STAFF REPORT: 02-10-2021 MEETING

APPLICATION NUMBER: 21-7050

ADDRESS: 1201 WASHINGTON BOULEVARD

SCOPE: DEMOLISH PORTION OF BUILDING AT REAR; REPLACE NON-HISTORIC STOREFRONTS, ROOFTOP ADDITIONS

ALLEY PROPOSED ELEVATION

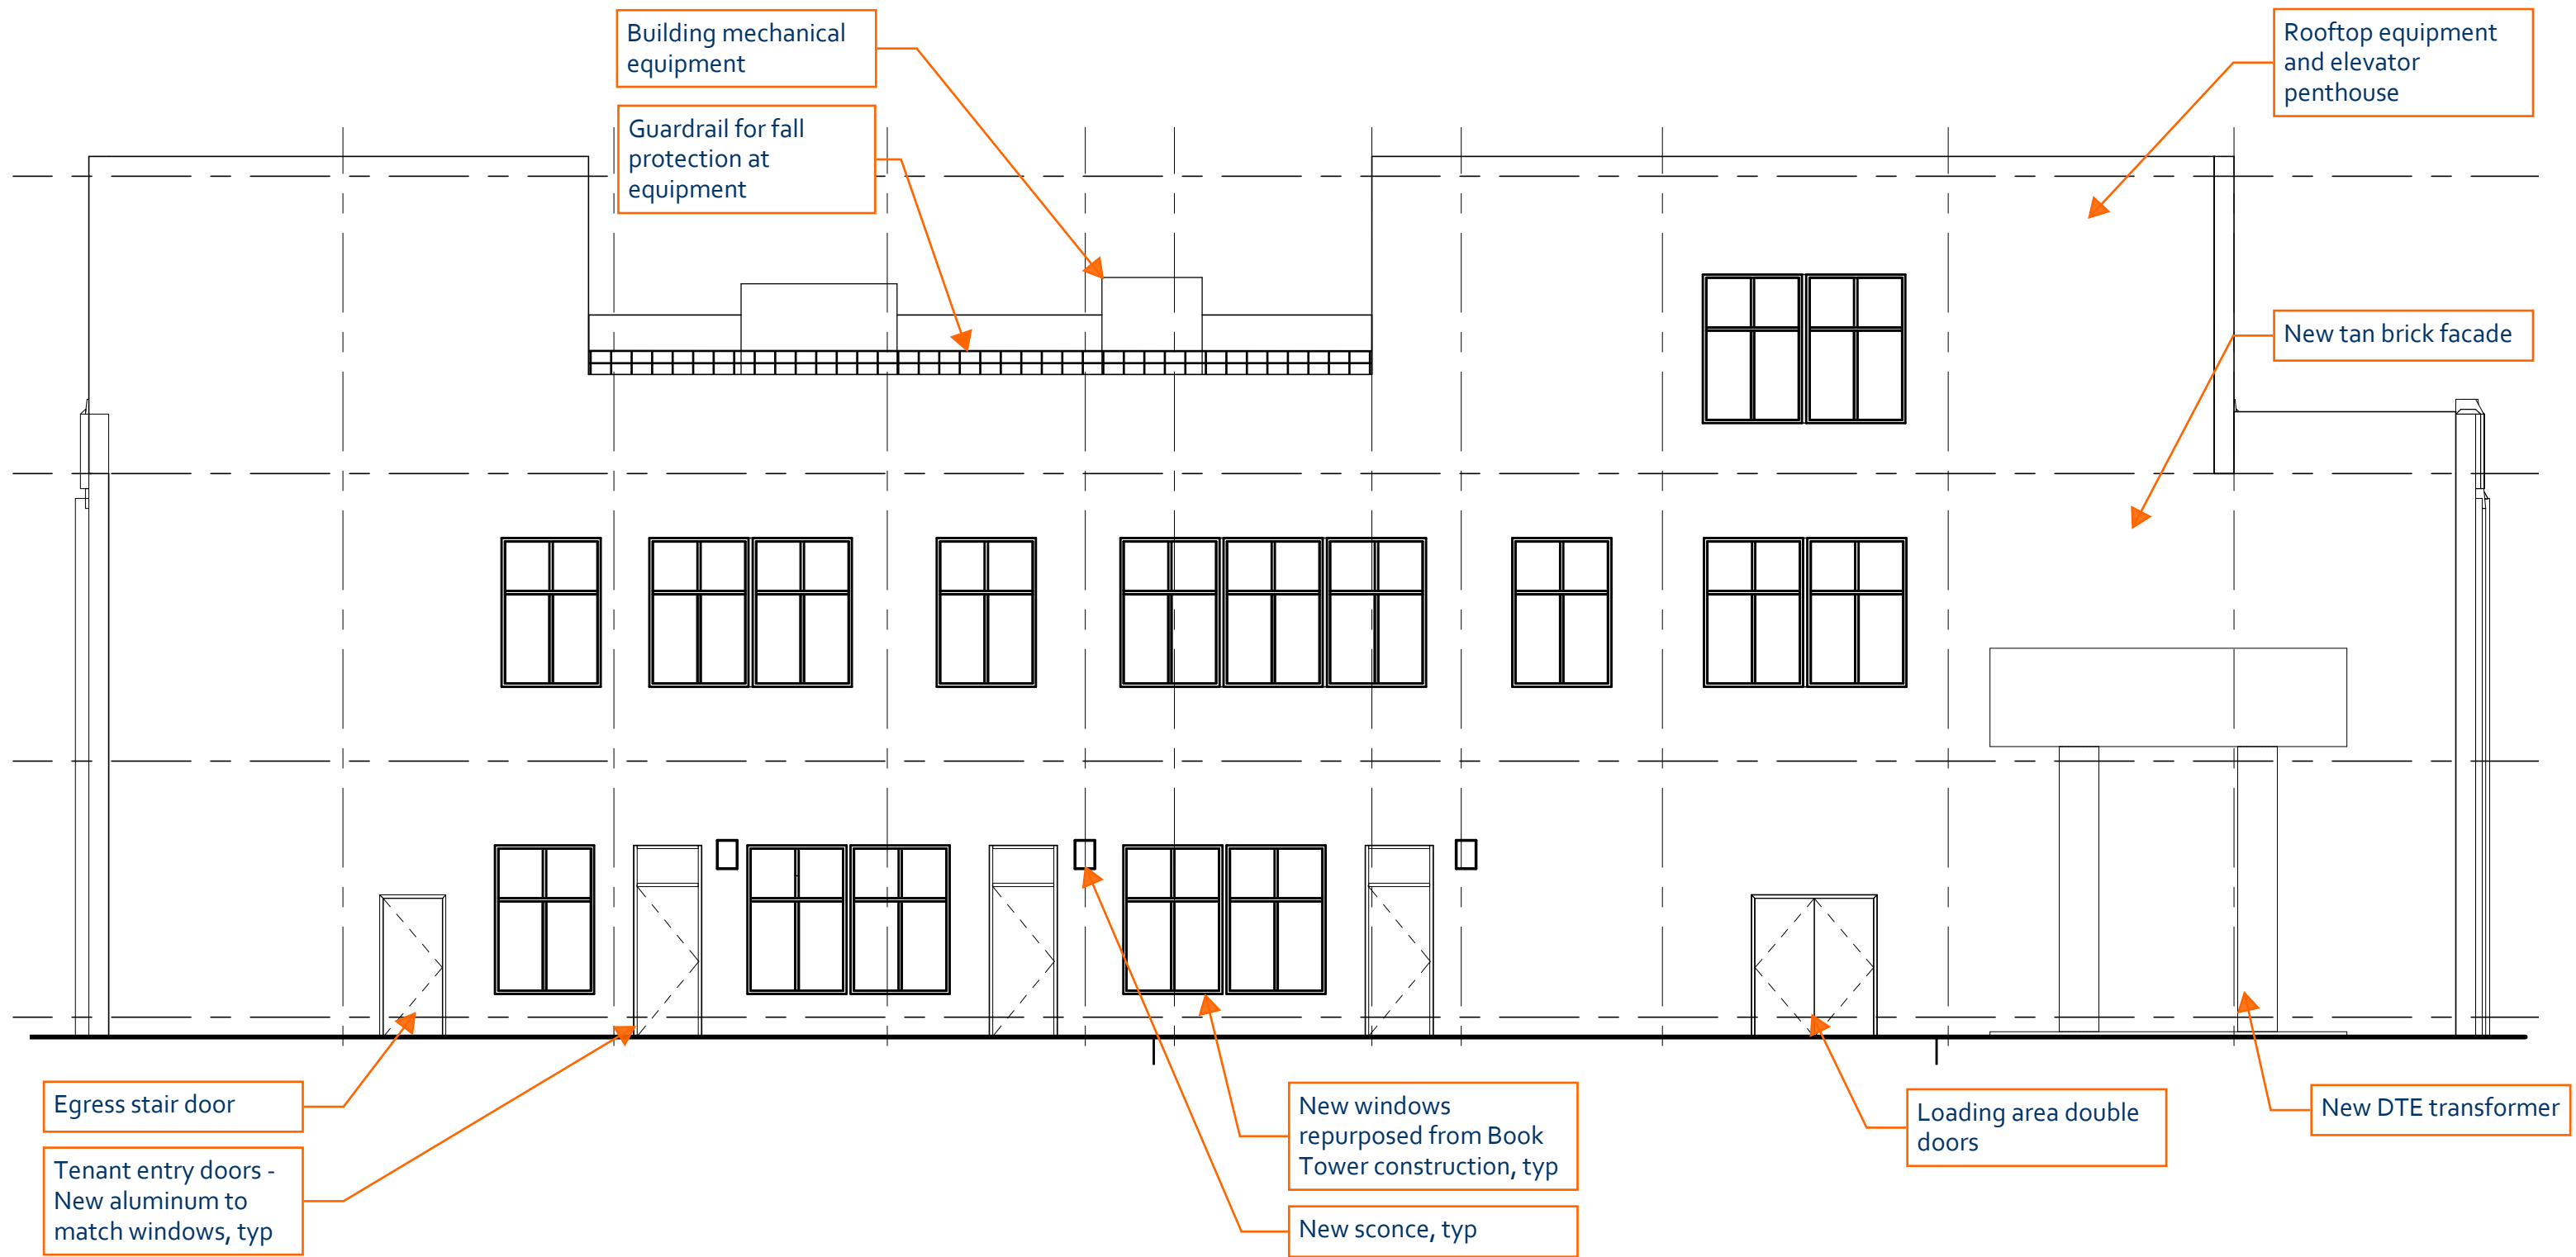
- After the demolition of the two westernmost State Street-facing bays, an exterior west wall will be constructed on the newly-shortened building. This wall will be clad in tan, non-historic sized brick to differentiate it from the historic elevations. *Needed: A wall section and sample of the selected brick.*
- Window and door openings for tenants will be created to offer street-level retail. *Needed: Catalog cuts for the tenant and loading/egress doors.*
 - New aluminum windows (previously installed at the Book Building and since removed) will be repurposed to provide glazing.
 - The non-operable windows will be grouped together at both the 1st and 2nd floors.
- A double metal door will be installed near the southern end of this façade and a utilitarian metal door will be installed at the northern end of this façade, for building loading and building egress access, respectively.

- A brick wall or parapet will help screen the rooftop equipment from the alley. *Needed: This should be shown on the new exterior wall section.*
